Pantera by Ghia

Technical Service Bulletin

APRIL 25, 1975

BULLETIN NO. 14

Fig. 18 – Article No. 117

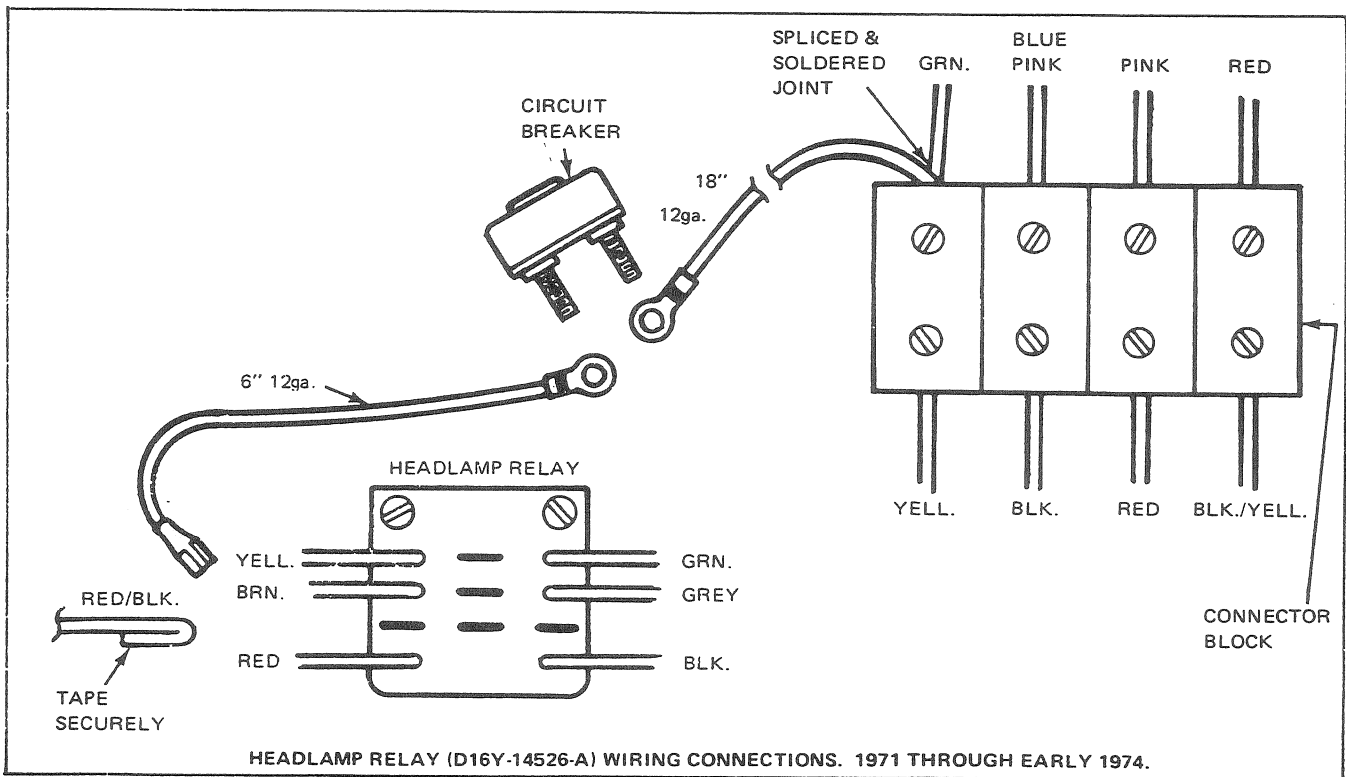
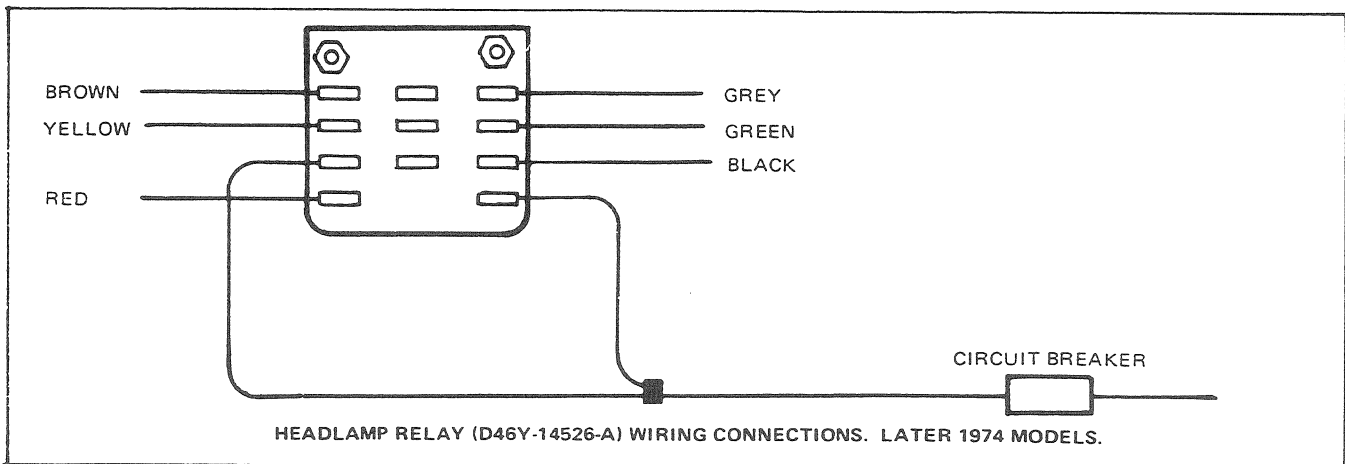
The relays, while identical in visual appearance, are not interchangeable due to internal design changes.

In the vehicles the type of relay required can only be determined by an examination of the wiring connections as shown in Figs. 18 and 19.

The D16Y relay has a bridge wire connecting the two ground terminals. The D46Y relay does not have the bridge wire between the terminals. D16Y relay can be converted to a D46Y type relay as follows:

Fig. 20 – Article No. 117

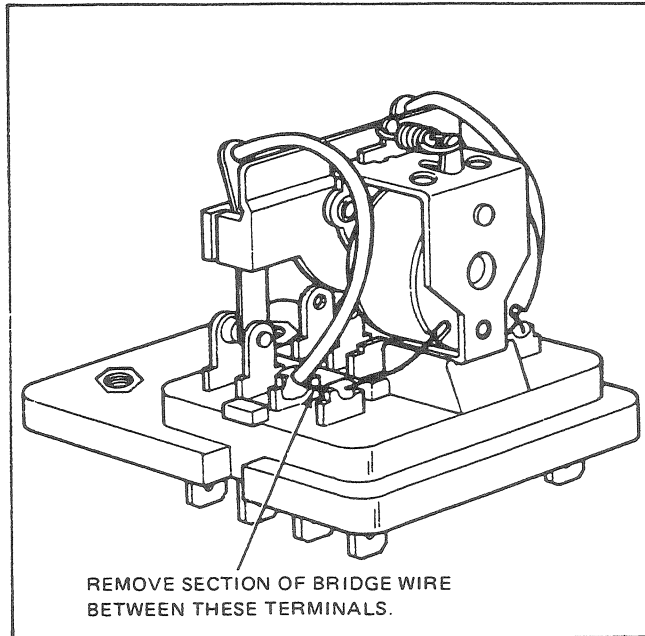
2. Remove the bridge wire connecting the two (2) ground terminals, (see Fig. 20) and replace the cover.
